THE ROVER COMPANY LIMITED
S E R V I C E D E P A R T M E N T

Rover Service News Letter No. 46

July 30th, 1954

Fig. 1. Clutch return spring.

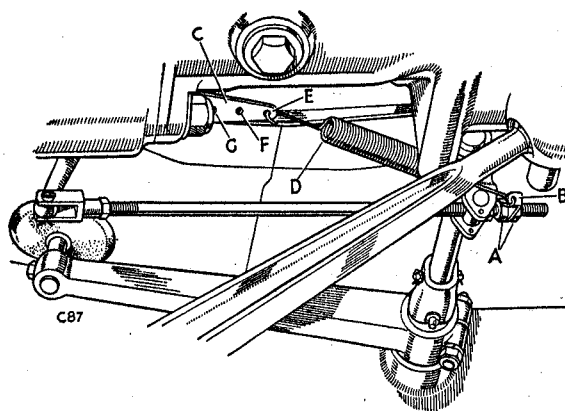
Item 60 SUBJECT: **CLUTCH OPERATION.**
 MODELS: All 1954 cars.
 MODIFICATION: As from cars numbered as below the clutch operating pedal return spring and anchor has been redesigned, to increase pedal loading and to permit alternative loadings if required.
 PART Nos.: Anchor for clutch spring on bell housing 1 246858
 Bracket for clutch spring on rod 1 248134
 Clutch return spring 1 246806
 COMM. Nos.: Cars numbered—
 "60": 43301552, 43330023, 43360024, 43630001 and 43660021 onwards.
 "75": 44302564, 44330637, 44360483, 44730001 and 44760017 onwards.
 "90": 45301776, 45330507, 45361123, 45830001 and 45860017 onwards.
 REMARKS: The new parts can be fitted to any earlier 1954 car provided the bracket, anchor and spring are all supplied and fitted. The method of fitting is clearly shown in the sketch below.

- (a) Locknuts.
- (b) Bracket.
- (c) Anchor.
- (d) Return spring.
- (e) Hole for 5 lb. loading.
- (f) Hole for 7½ lb. loading.
- (g) Hole for 10 lb. loading.
